Letter RO-1 – Sierra Club

SB 743 Analysis

Figure 1
Project Site Plan

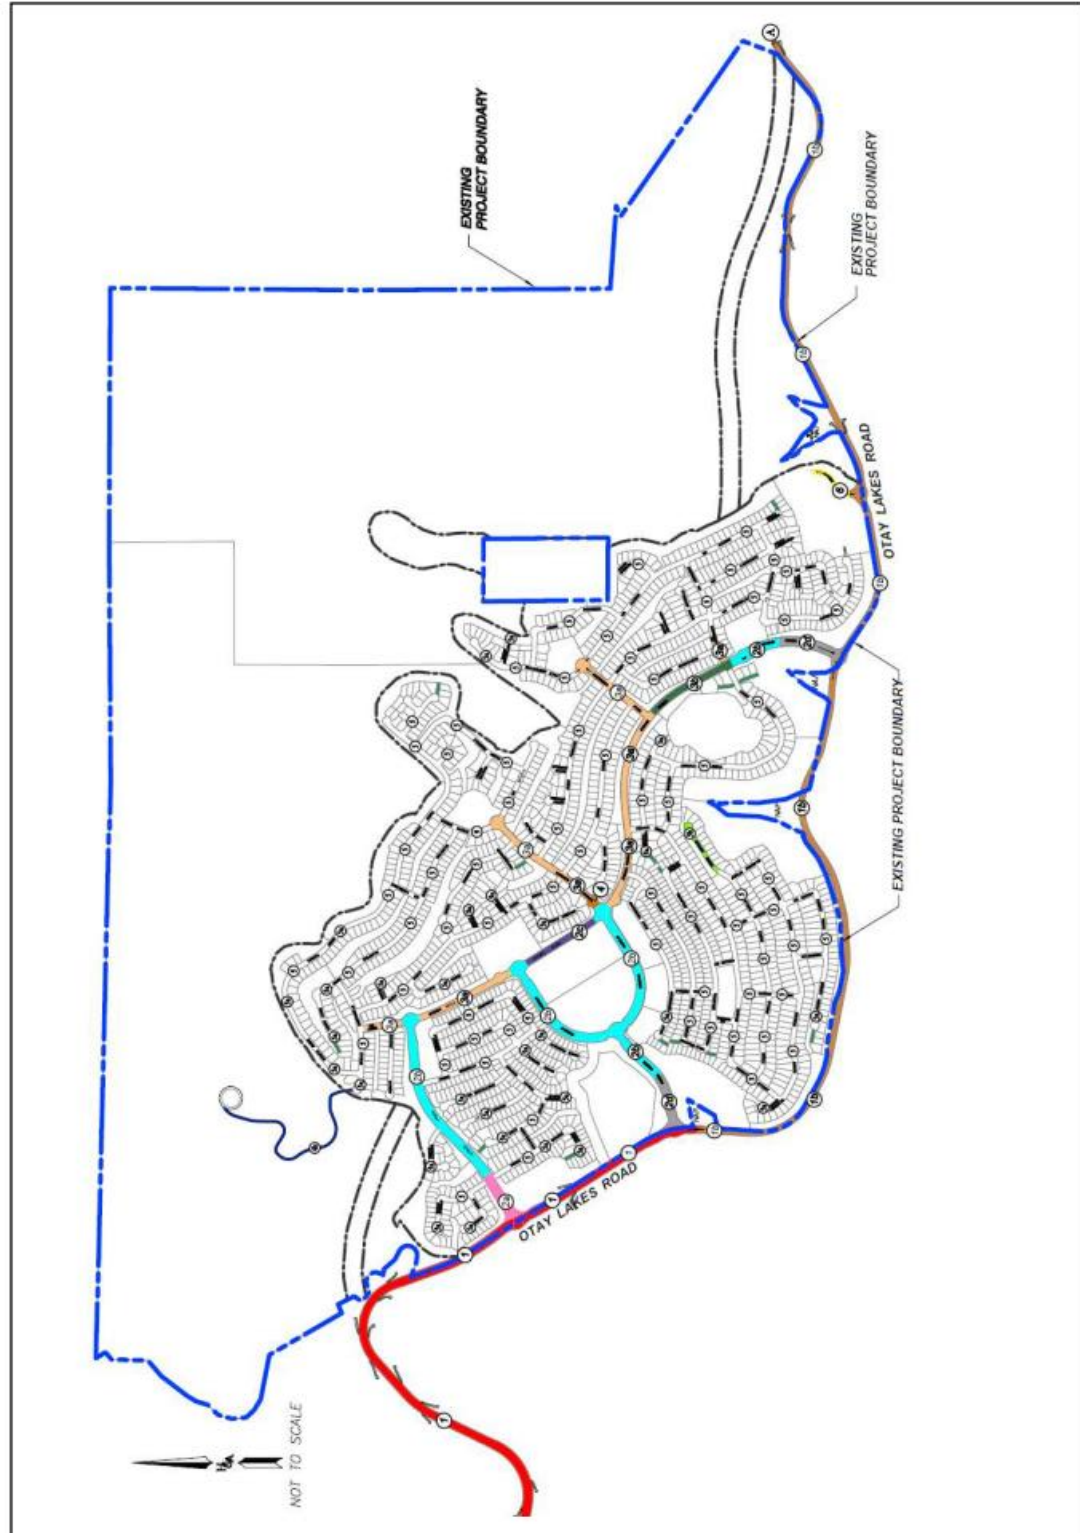
The VMT per capita analysis presented above provides a snapshot of the VMT per capita associated with the proposed Project/Alternative H. However, both the proposed Project and Alternative H would be developed as part of the Otay Ranch General Development Plan (GDP) sub-region approved by the City of Chula Vista and County of San Diego as part of the Sub-Regional Plan (SRP) on October 28, 1993. The Otay Ranch GDP land uses are predominantly made up of suburban densities and are similar to the proposed Project and Alternative H land uses. Since both the proposed Project and Alternative H would be part of the larger SRP with a mix of uses, it also is appropriate to evaluate the proposed Project and Alternative H VMT per capita as part of the Otay Ranch GDP as a whole. Figure 1 displays the full Otay Ranch GDP area, as compared to the San Diego Region.

To conduct this additional analysis, the VMT per capita for the Otay Ranch GDP was calculated using the SANDAG Series 13 Year 2035 Regional Model using the VMT methodology developed by SANDAG. Table 3 displays the VMT per capita for the Otay Ranch GDP. VMT output from the SANDAG model is provided in Technical Memorandum, Attachment C.

As shown in Table 3, the Otay Ranch GDP VMT per Capita, including the proposed Project/Alternative H, is projected to be 15.7 miles, which is higher than the 14.96 miles threshold based on the San Diego region. Therefore, when viewed as part of the larger Otay Ranch GDP, the proposed Project/Alternative H would still exceed the VMT per Capita threshold outlined in the *OPR Technical Advisory*, shown in Table 2. It should be noted, while TDM measures could help to lower the overall VMT per Capita generated by the Otay Ranch GDP, the proposed Project would not have the authority to implement or enforce these measures; therefore, no TDM plan is recommended at this time. However, since approval of the Otay Ranch GDP, additional projects have been approved representing over 10,000 residential units and ancillary development. These projects have included TDM measures that would further reduce the VMT per capita for the Otay Ranch GDP. TDM measures for these projects can be found on the City of Chula Vista website (<https://www.chulavistaca.gov/departments/development-services/planning/planning-digital-library/eir>), which illustrates that a TDM plan is proposed by each of these villages.

However, when compared to the County of San Diego Southwestern VMT per Capita, the Otay Ranch GDP VMT per Capita, including the proposed Project, is lower than the sub-regional VMT per Capita. Thus, the Otay Ranch GDP sub-region is more efficient than the County of San Diego Southwestern sub-region.
